CITY PLANNING COMMISSION

- APPLICATION:**
- A. Negative Declaration
 - B. Tentative Map to divide 9.8+ partially developed acres into 55 standard single family lots in the R-1 Zone.

LOCATION: Southwest corner Bell Avenue and May Street

WASHINGTON HEIGHTS (P88-467)

TENTATIVE SUBDIVISION MAP FOR
SUNRISE

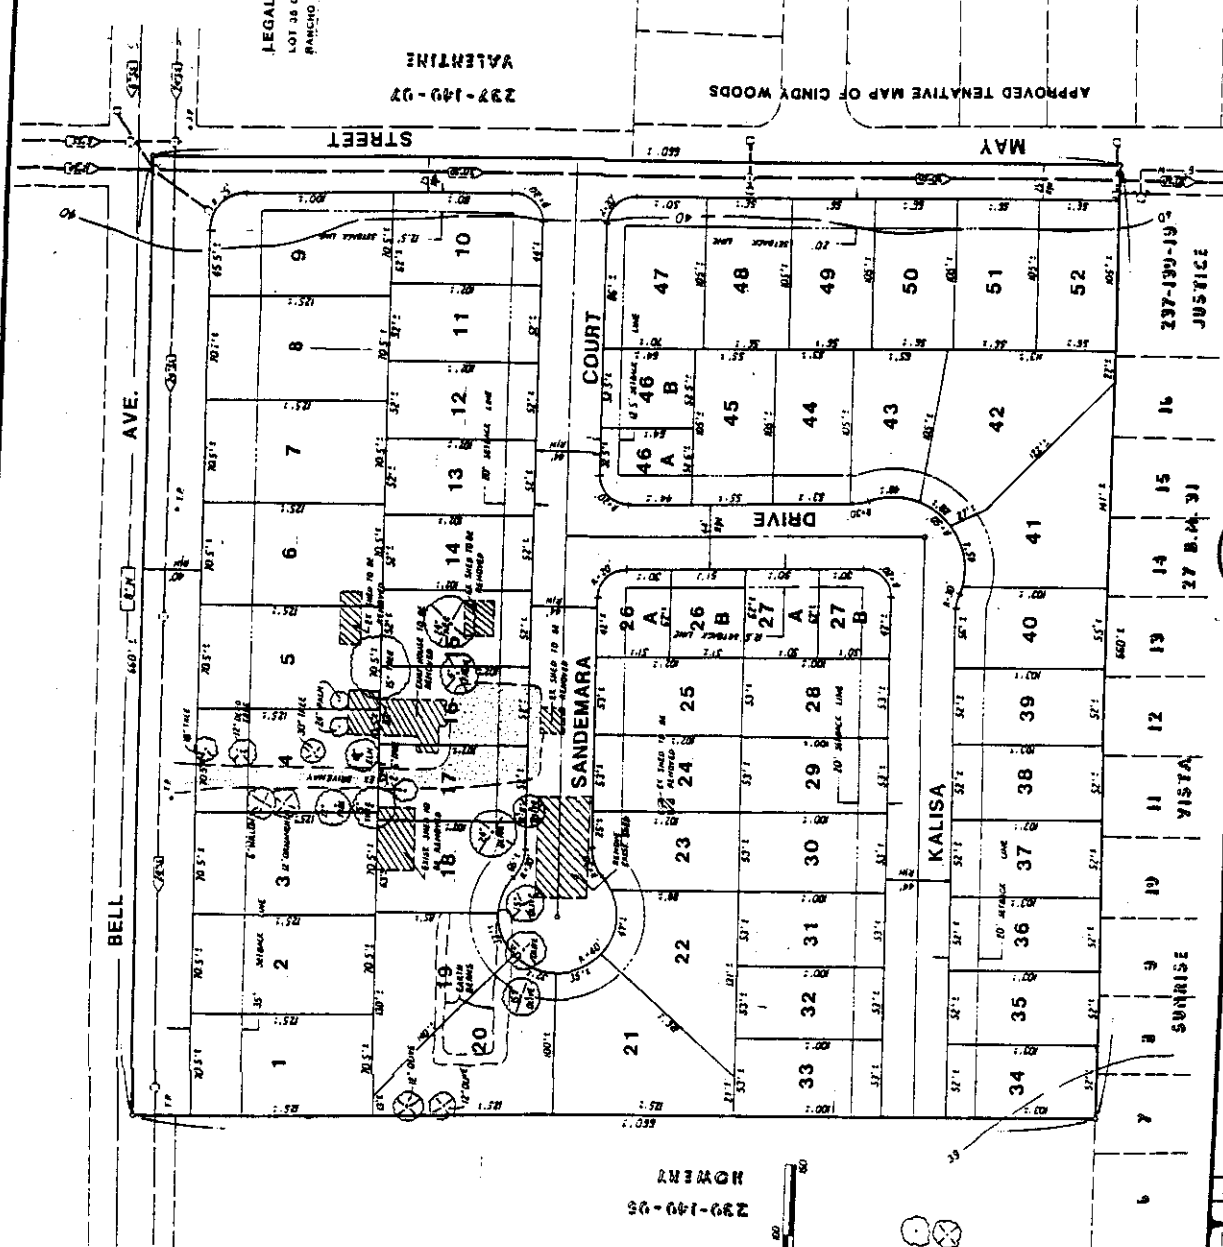
The applicant proposes 12 lots, lots 1 to 12, which back out onto Bell Avenue. Bell Avenue is proposed to be 80 feet in width and planned to be a major east-west street. In order to prevent an unsafe back-out situation, staff recommended increasing the lot depth and lot width/ The applicant has agreed to increase the lot depth from the original 105 feet to 125 feet but has not increased the lot width. Staff recommends that lots 1 to 12 be increased in width to a minimum of 70 feet in order to allow a hammer-head driveway and allow adequate front yard landscaping. The recently approved map for Pickard Woods on 2.27 acres creating 10 lots was designed with four lots fronting on Bell Avenue with a minimum of 70 feet of lot width. (P88-296). Lots established fore Linda Woods Unit 1 are 60 feet wide. After review of the site plans, the paved impervious areas for 60 foot wide lots exceed the maximum 40% of the required front yard coverage with the turn-around area and two car garage driveway. Staff has learned from past approvals where hammer-head driveways are required to eliminate backout maneuvering onto major streets, if the lots are not wider than 60 feet, the site design normally exceed the 40% impervious area allowed in the front yard as per the City Zoning Ordinance. Staff recommends the applicant revise the tentative map for lots 1 to 12 to be a minimum of 70 feet in width. This reduces the lot count by three units. However, if the applicant can demonstrate that the specific building footprint can comply with the front setback 40% coverage and turn around with a lot less than 70 feet in width. Staff would consider a reduced lot width.

Since the overall net density is 7.1 dwelling units per net acre, staff recommends the addition of at least three corner duplex or halfplex units on three corner lots in the subdivision. With this modification, the density of seven dwelling units per net acre is maintained.

Kalisa Drive is proposed as a dead end street until development occurs to the west. Staff recommends that an appropriate turning area be provided to allow large emergency vehicles such as fire trucks the ability to turn without requiring backing up. Design of either a cul-de-sac or offsite improvements shall be reviewed and approved by the City Traffic Engineer and Planning Director. Staff recommends that the turn-around portion of the driveways on Bell Avenue be constructed of turf block or paverstone and that the area between the turn-around and sidewalk be landscaped and bermed. Staff will review these site plans for appropriate landscaping and building materials prior to issuance of building permits.

22. Applicant/developer shall provide a temporary turnaround at the west end of Kalisa Drive to the satisfaction of the City Traffic Engineer.
23. The tentative map shall be revised to show minimum lot widths of 70 feet and 125 lot depth with a 35 foot building setback along Bell Avenue. Smaller lot width may be as approved if the applicant complies with all yard setback and coverage requirements to the satisfaction of the Planning Director.
